SUBJECT: NEW VEHICLE DEMONSTRATION / DELIVERY HOLD

Safety Recall 22S26 - *Supplement 4*

Certain 2020-2021 MY Expedition, 2020-2021 F-150,
2020-2021 Navigator, 2020-2022 Super Duty Vehicles
Both Front Wiper Arm Replacement

FIGURE 2

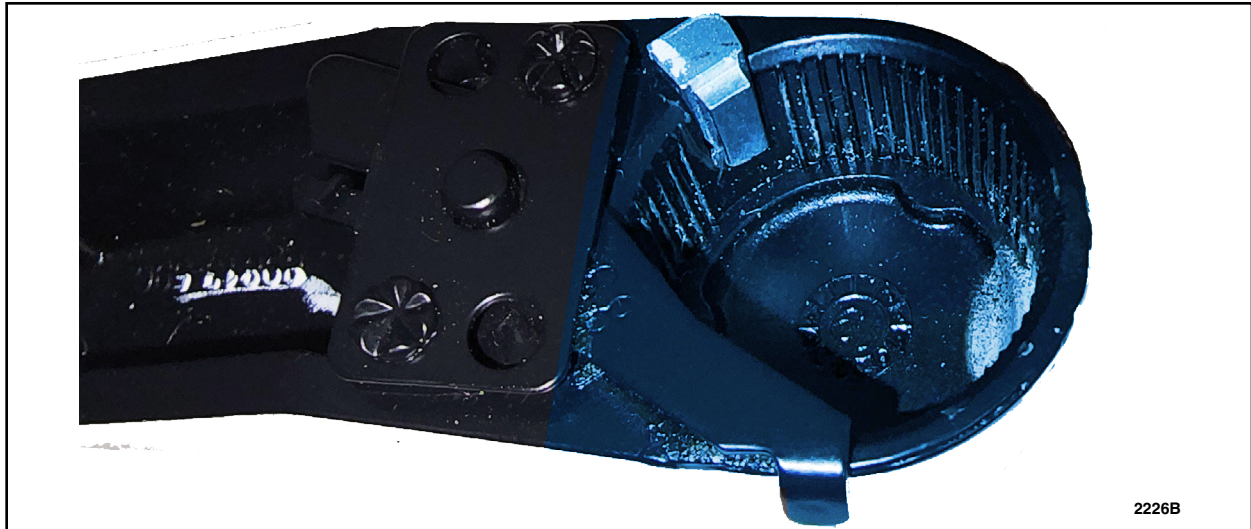
3. Clean the wiper head area and key with rubbing alcohol and let it dry before applying the glue.
See Figure 2.

FIGURE 5

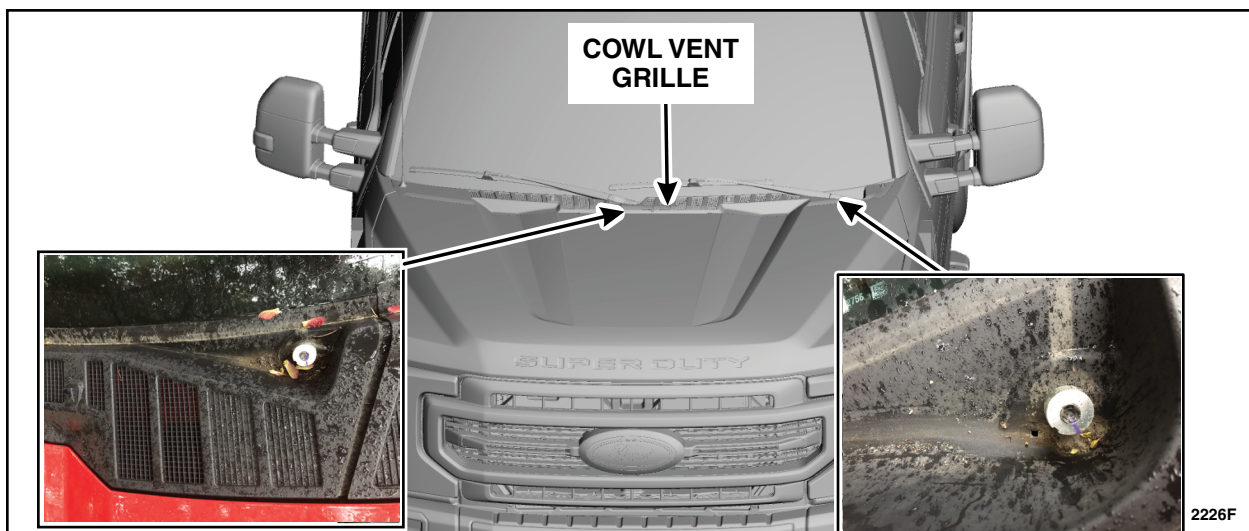
9. Check the cowl vent grille for the wiper arm key. See Figure 5. Was it located?

Yes - Continue to Step 10.

No - Reinstall wiper blades per WSM procedures in Section 501-16, wait for new wiper arms to be available.

FIGURE 6

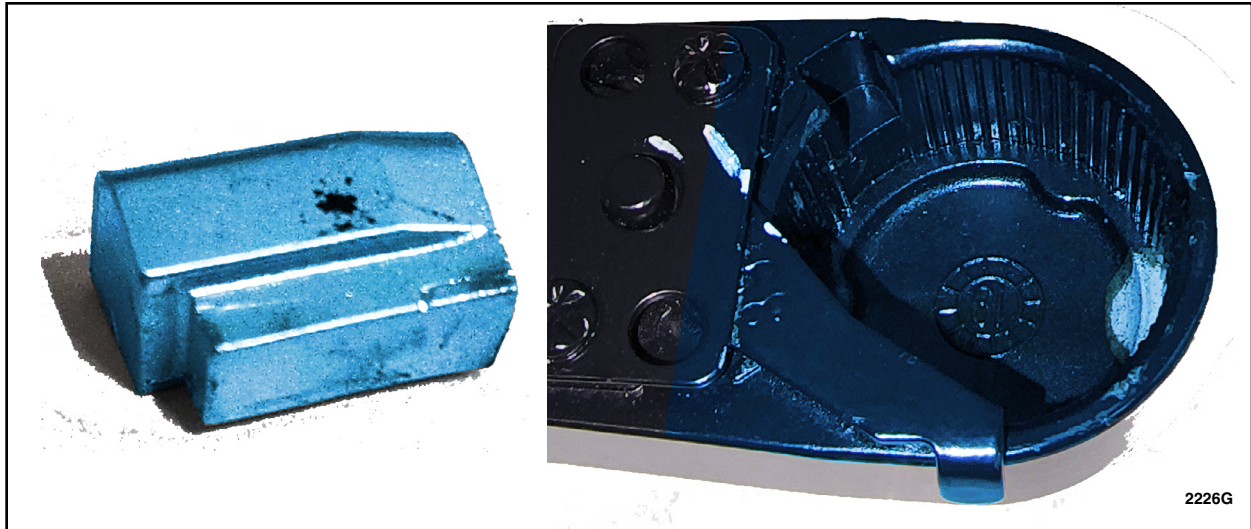
10. Clean the wiper head area and key with rubbing alcohol and let it dry before applying the glue.
See Figure 6.

FIGURE 7

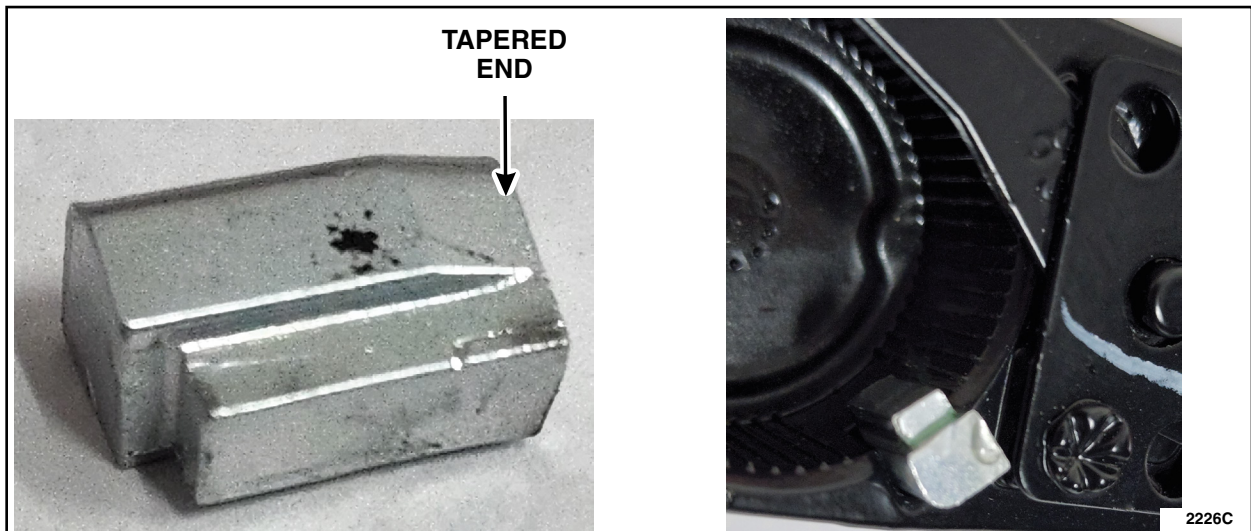
11. Insert key into the wiper arm head. If necessary use a small hammer to tap it in. Key does not sit flush with the head. See Figure 7.

NOTE: Tapered end needs to be inserted first into the head.
